ZEE Systems, Inc.

SERVICE BULLETIN 83-001-2

1.0 EFFECTIVITY: ZEE Systems, Inc. P/N SZ83-001-1B Motor Compressor Condenser Assembly (MCC) installed as part of STC SA1734GL

2.0 PURPOSE: To modify the MCC to use R-134a refrigerant.

WIRING DIAGRAM 1.

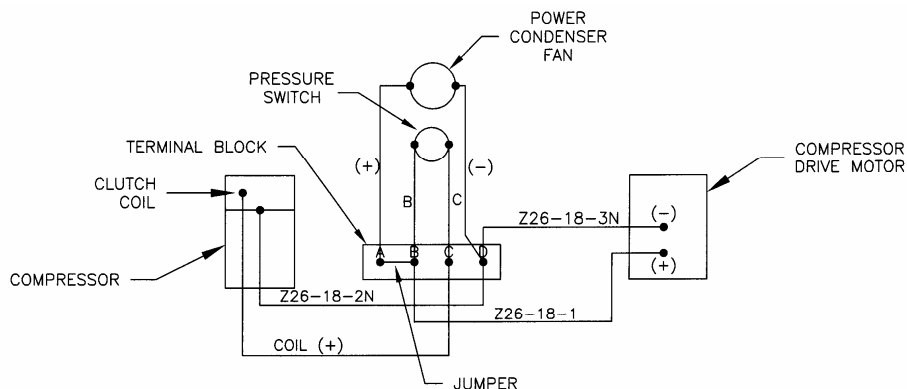
10.3.2 To check to compressor clutch you will need to by pass the Z99-032 High/Low Pressure Switch. Remove COIL (+) wire from C post on the terminal block. Apply 28 VDC to COIL (+) wire with any ground. The clutch should pull in with an audible click. After test return wire COIL (+) to C post of the terminal block.

DO NOT CHECK THE CLUTCH OPERATION BY APPLYING POWER DIRECTLY TO POST C ON THE TERMINAL BLOCK. DAMAGE TO WIRING MAY OCCUR AS A BACK FEED MAY TRY TO ENERGIZE THE COMPRESSOR DRIVE MOTOR.
